Response to SDAA Audit Question

Question Number: A-19.1-53

Receipt Date: 11/20/2023

Figure 1. Containment Vessel Top Support Structure Assembly

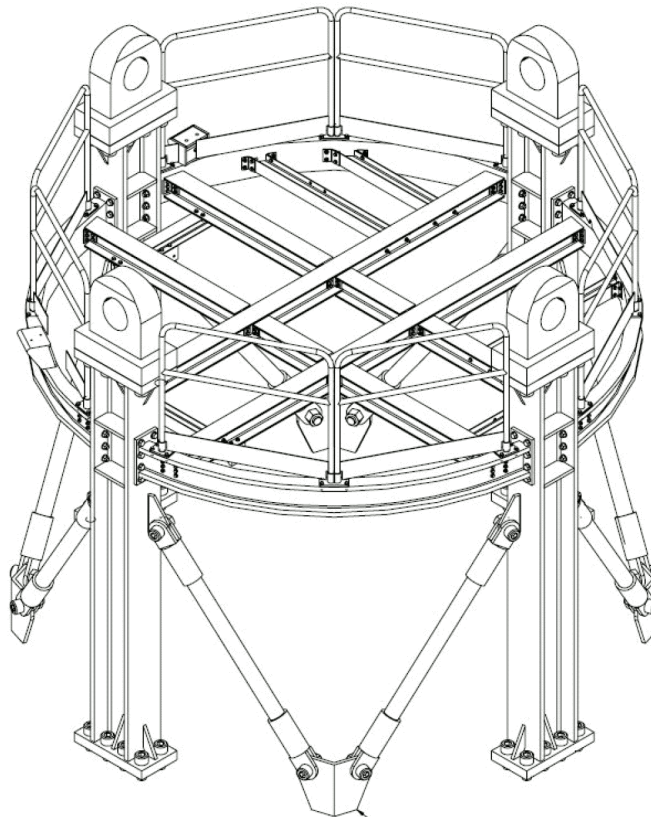
- a) NuScale is requested to explain if the capability of the containment isolation valves (CIVs) to close is compromised, given that the strike to the operating module has sufficient force to cause pipe breaks. In this context, NuScale is requested to describe any protection for the CIVs provided by the Module Top Support Structure and the Lower Block Assembly (LBA), located at the bottom of the main hoist which have been re-designed in the SDA compared to the DCA.

a) The safety-related chemical and volume control system (CVCS) containment isolation valves are located on top of the containment vessel and under the NuScale Power Module (NPM) top support structure (TSS). As shown below in Figure 1, Containment Vessel Top Support Structure Assembly, and in FSAR Figure 9.1.5-3, the TSS is composed of diagonal lifting braces and lifting lugs, and provides structural support for piping and valves. The lower block assembly is located at the bottom of the main hoist and interfaces with the TSS; the lower block assembly provides the connection method for the Reactor Building crane to connect to, lift, and carry an NPM between an operating bay and the refueling bay. {{
